Project	<b>IEEE 802.16 Broadband Wireless Access Working Group</b> < <a href="http://ieee802.org/16">http://ieee802.org/16</a> >	
Title	<b>Evaluation of the Space Time Code Proposal (reply to comment 459)</b>	
Date Submitted	<b>2004-07-08</b>	
Source:	Wen Tong, Peiying Zhu, Mo-Han Fong, Jianglei Ma, Hang Zhang and Ming Jia  Nortel Networks 3500 Carling Avenue Ottawa, ON. K2H 8E9 CANADA	Voice: (613)-763-1315 Fax: (613)-765-7723  <a href="mailto:wentong@nortelnetworks.com">wentong@nortelnetworks.com</a>
Re:	IEEE 802.16e D3 Draft	
Abstract	Evaluation of the Space Time Code Proposal	
Purpose	The evaluation of the 4x1 STC code performances is presented in this contribution. The proposed 4x1 STC code drastically increase the decoding complexity by 9~17 times to achieve the same performance for QPSK modulation, such a complexity increase is exponentially high for higher order modulation (for 16QAM it requires to de-map 256QAM for 64QAM it requires to de-map 4096QAM) and any possible performance advantage due to the full diversity is diminished. Therefore there is no justification for changing the currently defined IEEE802.16-2004 4x1 code.

# Evaluation of the Space Time Code Proposal (Re

Figure 1 Raw Bit Error Rate Performance

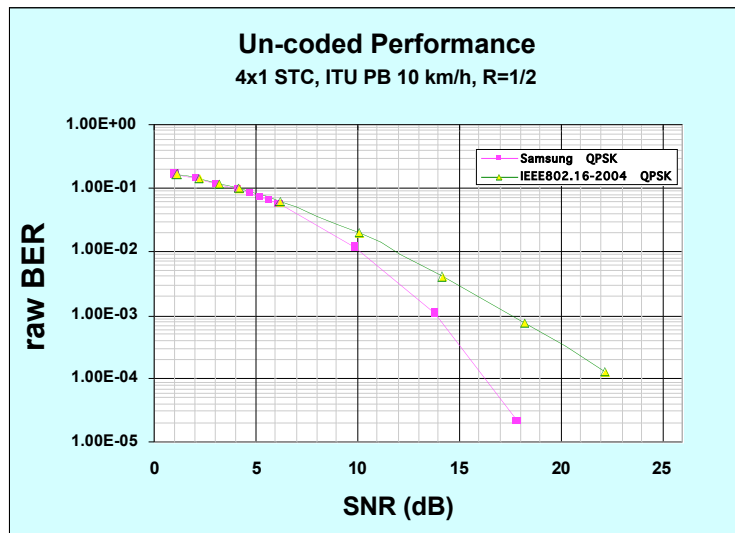
From Figure 1 we can see the proposed code does have the diversity advantage over the existing IEEE802.16-2004 4x1 code in the *raw bit error rate*. Figure 2 shows the CTC coded QPSK Rate=1/2 bit error rate at decoder output.

Figure 2 Coded Bit Error Rate Performance

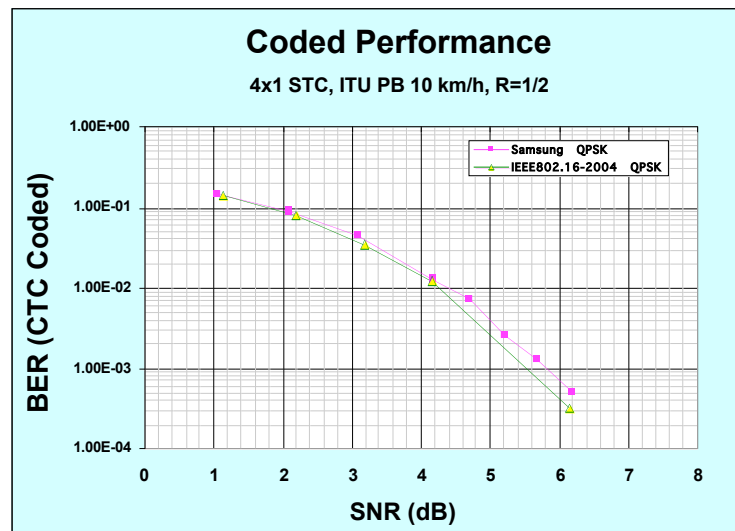
Clearly, with the FEC coding, the performance the proposed STC code is the same as the IEEE802.16 4x1 code (see Figure 2). Therefore, based on performance alone, there is no justification for changing the current spec.
